# Product Change Notification

Product Group: SIL/Thursday March 27, 2025/PCN-SIL-016-2025-REV-0

## Process improvement for HVM PPAK8X8LR BWL package leadframe design change

### PowerPAK® 8 x 8 LR BWL Outline Comparison

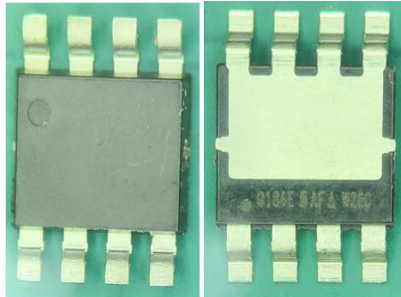
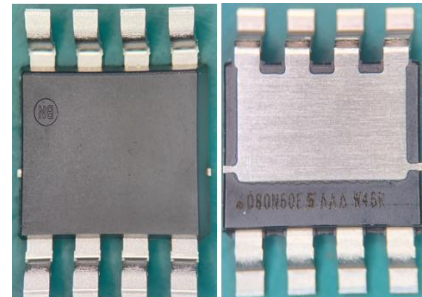
**Description of Change:** Vishay Siliconix announces new leadframe design for PPAK8X8LR BWL package for High Voltage Commercial power MOSFETs. This change is to improve process to resolve mold flash on PPAK8X8LR BWL package.

**Expected Influence on Quality/Reliability/Performance:** There will be no effect on the quality, reliability, or performance. There will be no changes in minimum and maximum values on the datasheet. The finished good appearance and outline dimension variance are shown in annex on page 3 & 4.

### Outline Drawing Comparison

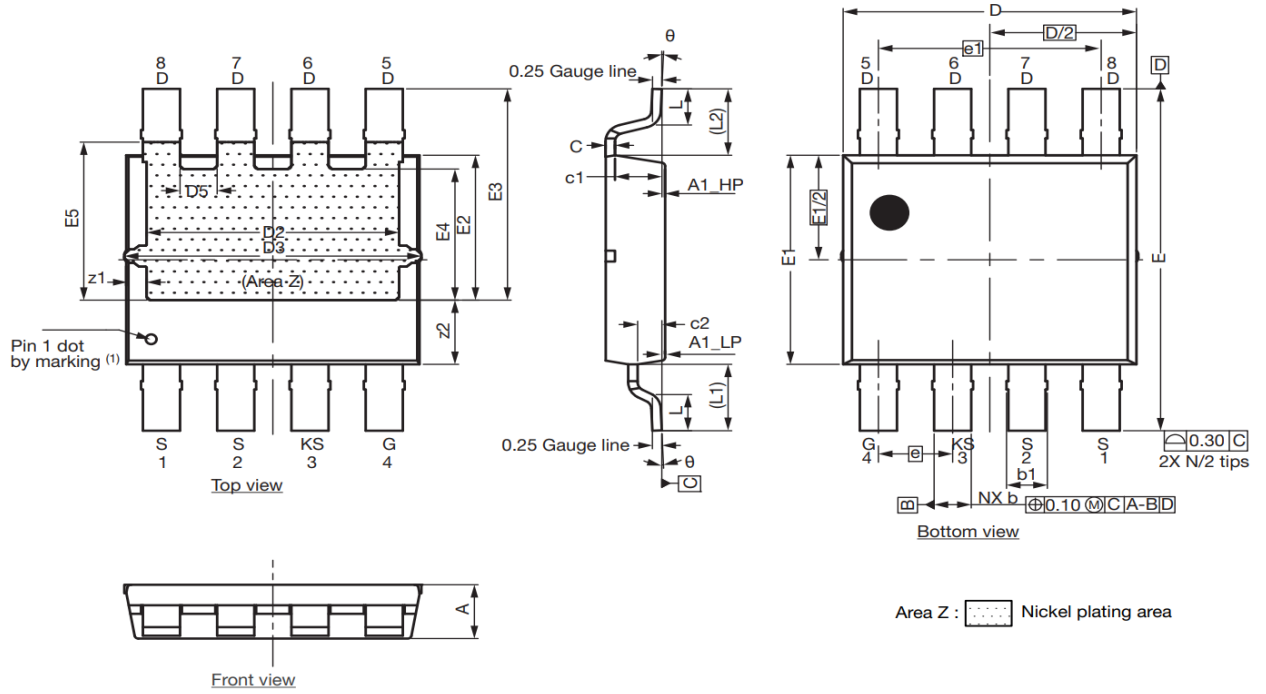
Before			After			Change (Before vs. After)
Symbol	Min	Max	Symbol	Min	Max	
A	1.55	1.65	A	1.55	1.65	None
A1_LP	0.035	0.135	A1_LP	0.035	0.135	None
A1_HP	0.035	0.135	A1_HP	0.035	0.135	None
b	0.97	1.13	b	0.97	1.13	None
b1	1.07	1.23	b1	1.07	1.23	None
c	0.254 ref.		c	0.254 ref.		None
c1	1.26 ref.		c1	1.26 ref.		None
c2	0.63 ref.		c2	0.63 ref.		None
D	7.80	8.00	D1	7.80	8.00	None
D2	6.70	6.90	D2	6.70	6.90	None
D3	7.95	8.15	D	8.00	8.20	<b>+0.05 / +0.05</b>
D5	0.90	1.10	D5	0.90	1.10	None
e	2.00 BSC		e	2.00 BSC		None
e1	6.00 BSC		e1	6.00 BSC		None
E	9.92	10.42	E	9.92	10.42	None
E1	6.12	6.32	E1	6.12	6.32	None
E2	4.21	4.41	E2	4.21	4.41	None
E3	6.18	6.43	E3	6.18	6.43	None
E4	3.80	4.00	E4	3.80	4.00	None
E5	4.70 ref.		E5	4.70 ref.		None
L	0.90	1.15	L	0.90	1.15	None
L1	1.80	2.10	L1	1.80	2.10	None
L2	1.80	2.10	L2	1.80	2.10	None
Z1	0.45	0.65	Z1	0.45	0.65	None
Z2	1.81	2.01	Z2	1.81	2.01	None
θ	0°	5°	θ	0°	5°	None
